# **Site Allocations Development Plan Document**

**Representations made by  
individuals (Reg 20)**

**This document contains all the representations made by individual residents during the regulation 20 consultation process on the Site Allocation Development Plan Document (SADPD).**

### Goddard House and Holyoak Road with Lambeth Council's development proposal

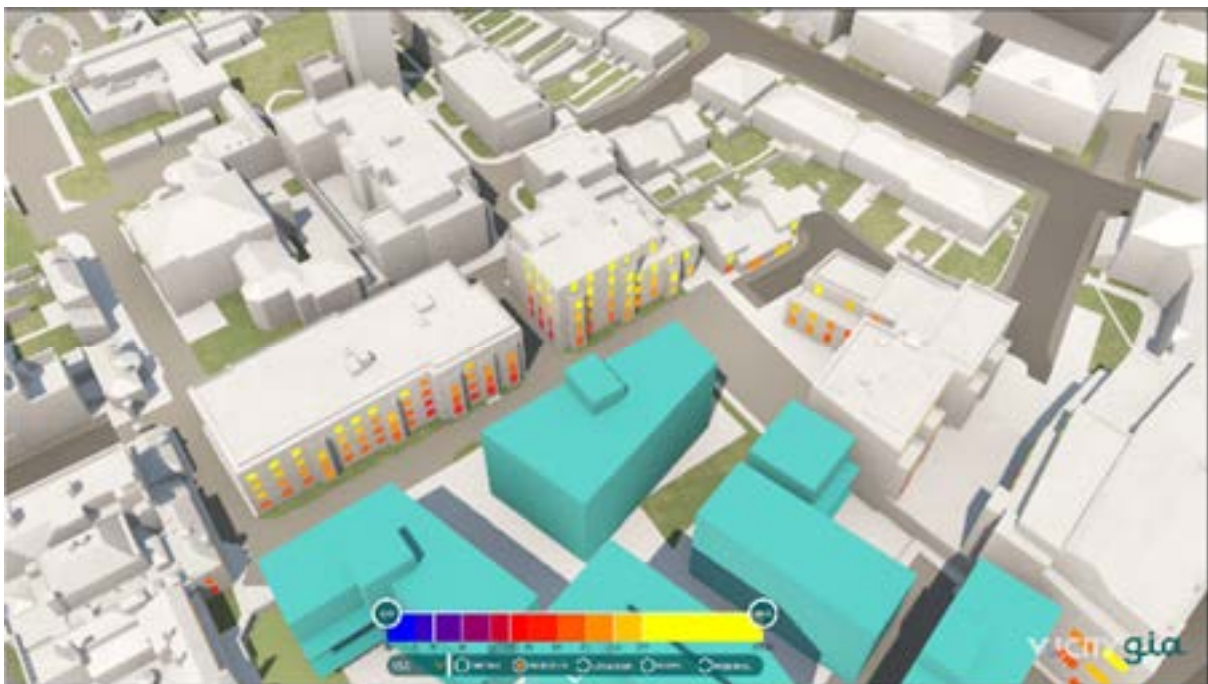
53. I would note that sunlight and daylight information for these properties was also omitted from the supporting report, despite as can clearly be shown in Figure 3 below, the 'gap' between the 130 -138 Newington Butts block and the 1 - 9 Holyoak Road block being infilled by the proposed development.

9. We're missing a chance to build more homes for families, which Lambeth really needs right now, especially since families are leaving and schools are closing.

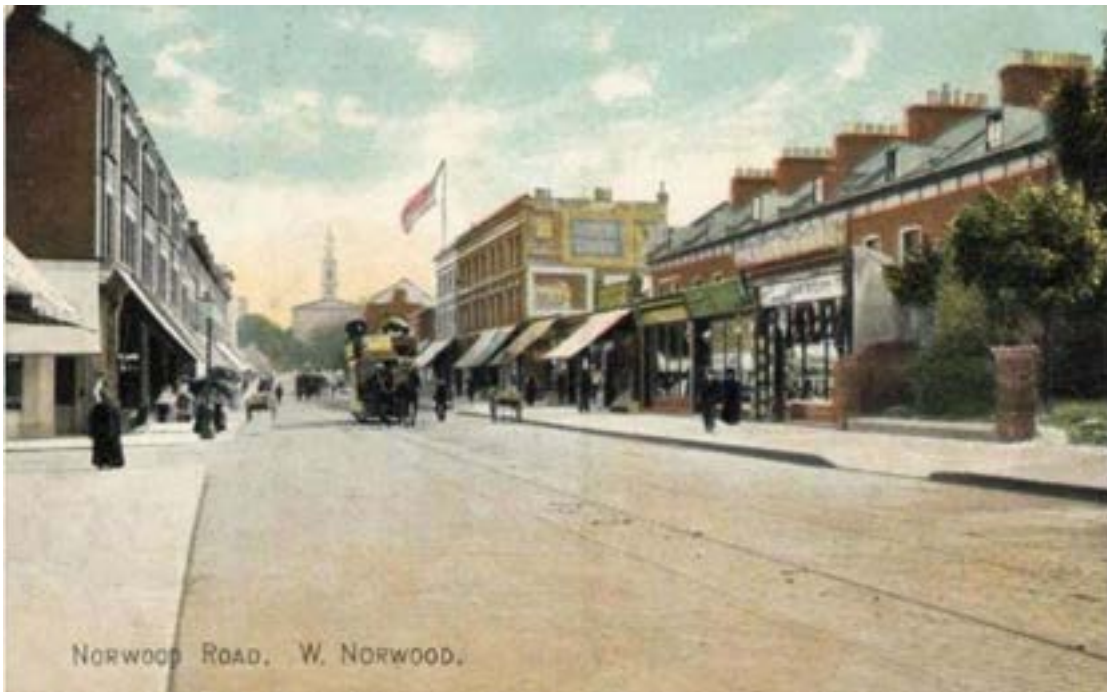
4. The concerns we raised about how the plans would affect our neighbours, like being overlooked or losing light, have been completely ignored, even though Lambeth has rules about this in their plan.

5. The plans want to change a rule made in 1985, that protects the privacy of people living near the site, to change the current boundary wall height.
6. Parking and pollution is already a big problem around Brixton, one of the highest in London, so it's very important that the new homes don't get parking permits, except for a limited number of people who need them because of a disability.

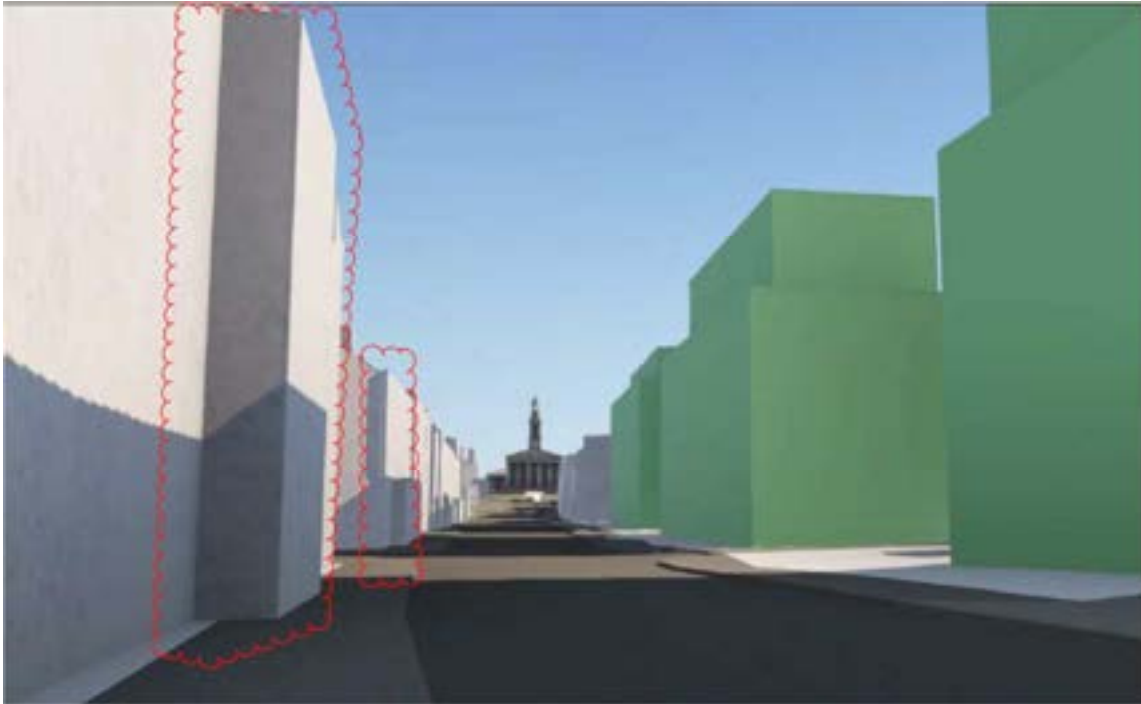
**CAUTION:** This email originated from outside of the organization. Do not click links or open attachments unless you recognize the sender and know the content is safe.

Brian Clivaz

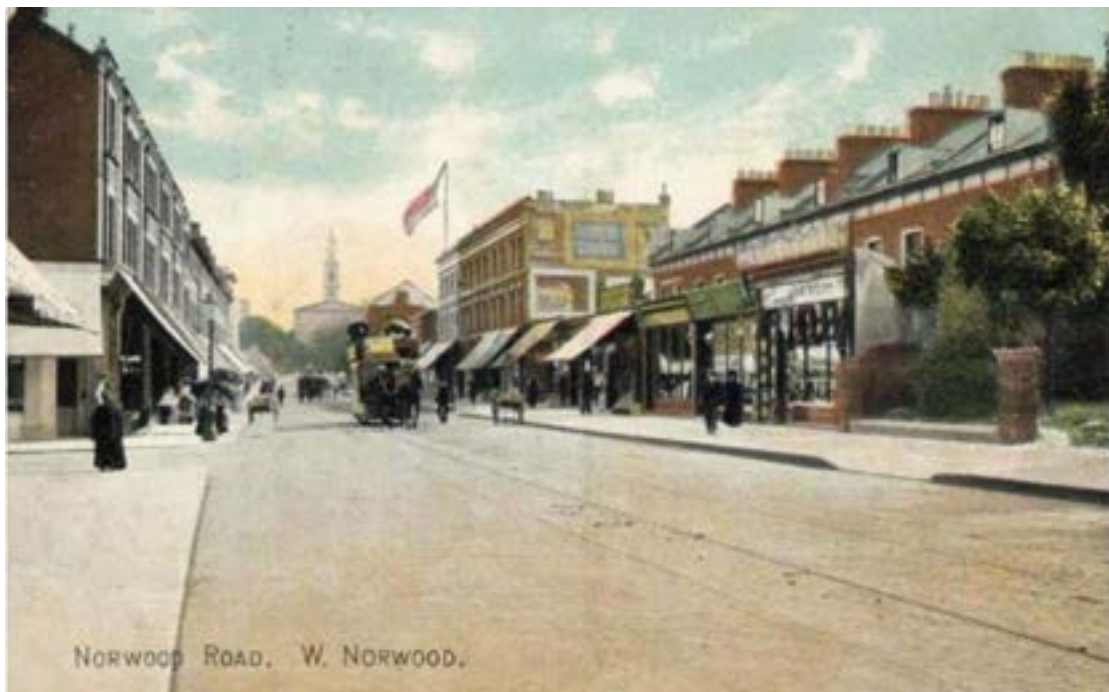
1. The plans attempt to cram an excessive number of housing units (210) onto the site, and I'm worried that the site owners actually desire to build more than twice that amount!

2. In the initial Lambeth Council consultation, a lower range of units was suggested, between 120-170. This was considered an 'optimized' level, so I'm troubled by the claim from Lambeth Council that they can nearly double that.

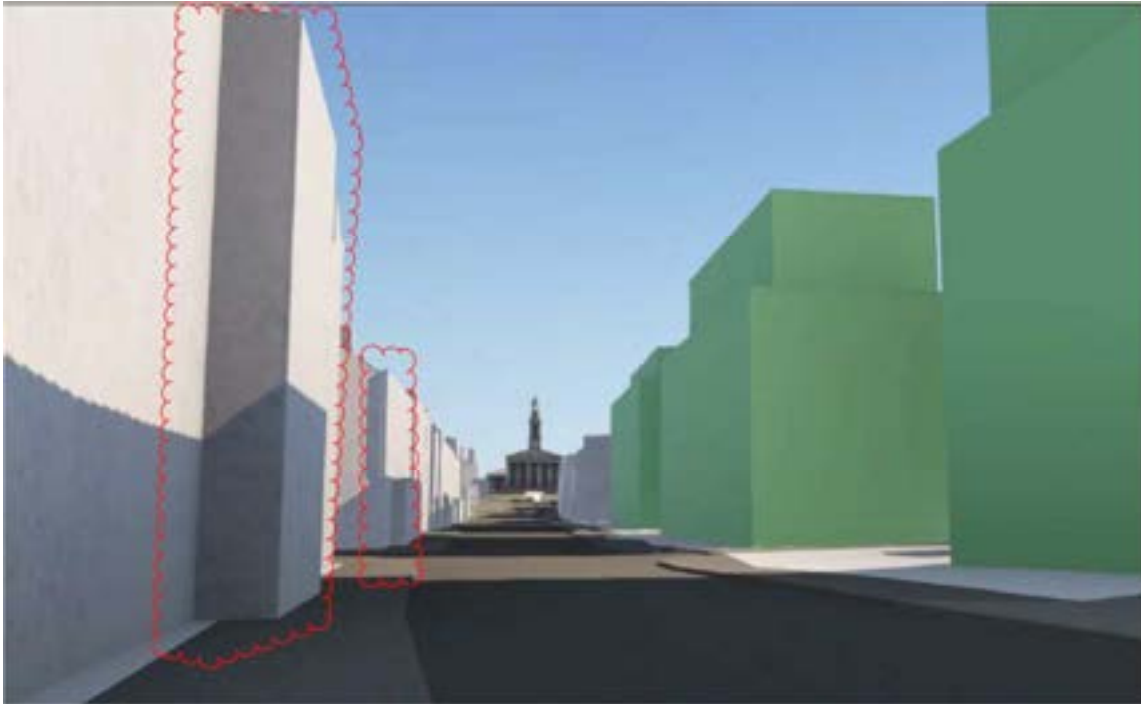
**From:** Blandine Baiget [REDACTED]  
**Sent:** 01 May 2024 11:40  
**To:** SADPD  
**Subject:** Objection site 18

**Categories:** Red category

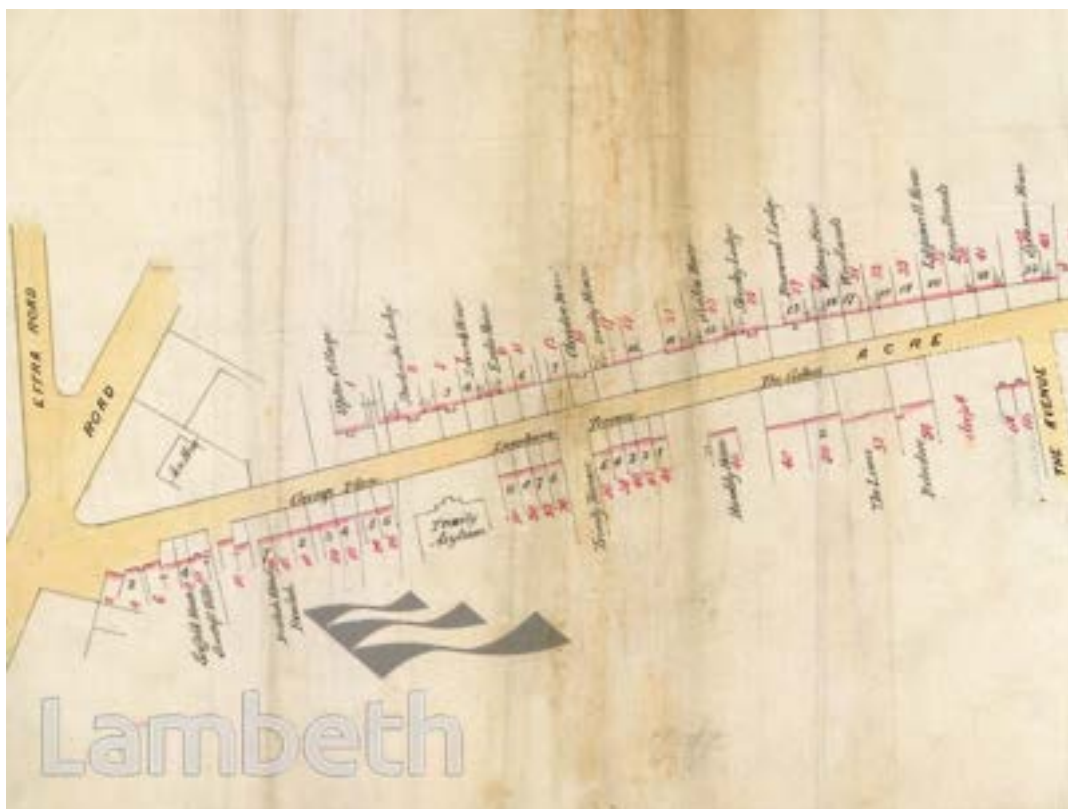
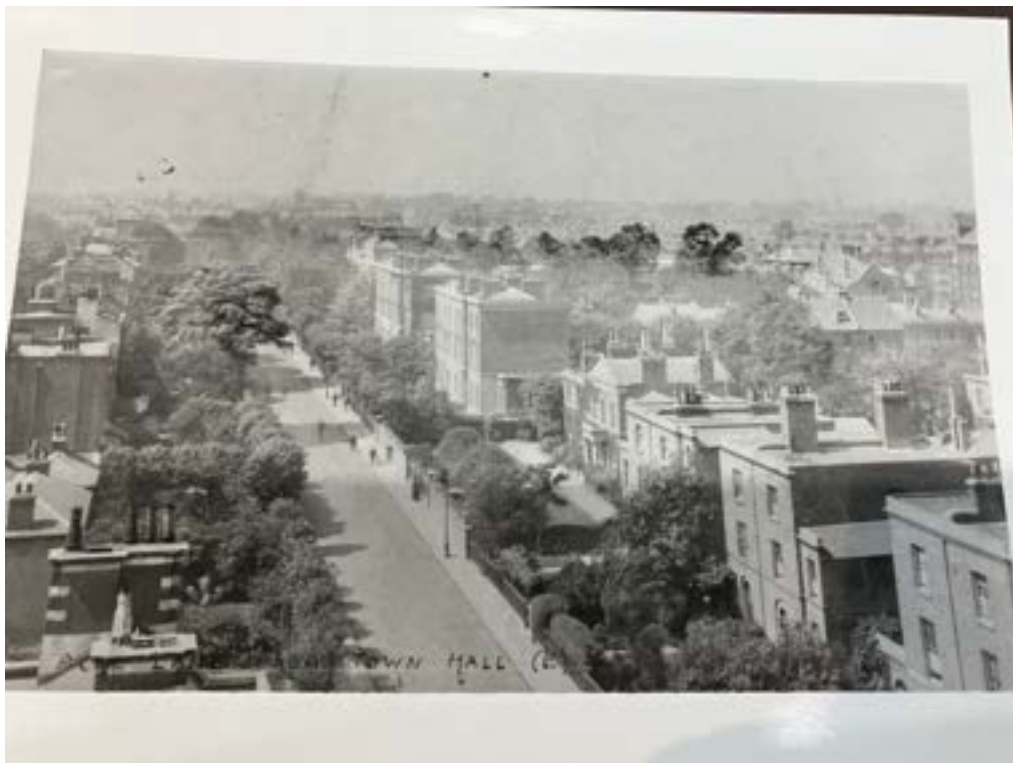
I appreciate Lambeth does need more housing, and I am supportive in principle about developing the Tesco site, but the current proposals would pack too many units into a massive complex that will loom over the surrounding neighbourhood. The height and density should be scaled back, so that the height is similar to the surrounding neighbourhood, and less dense to allow for green spaces near to the boundaries of Baytree and Porden Roads.

I am more concerned that the published responses to the Reg.18 consultation revealed that HSBC, who hold a 999-year lease of the Tesco site, believe that it can yield between 420 - 470 dwellings! **Again, this is not based on sound design-led principles, but a site owner wanting to maximise density and therefore maximise profit.**
